Attention Jo Dowling
London Borough of Barnet
Re: Planning Application **H/04017/09**

Mill Hill East Development Site NW7

Review in MHPS Committee after Outline Application made 2009

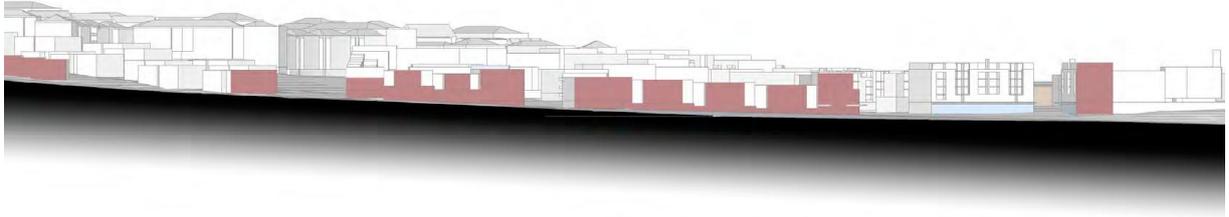
When our Committee looked at the new elevation to Bittacy Hill – figure 6.26 on page 71 of the Design Principles Document - we realised we were deeply sceptical about the attractiveness of the scheme. The elevation has nothing to do with Mill Hill East.

When we looked at this drawing and realised that the largest existing elements were the smallest elements of the new elevation - it simply showed how over developed the scheme would be – even when viewed from adjacent roads. There is a huge loss of green space and an obviously high density that is simply not going to work.
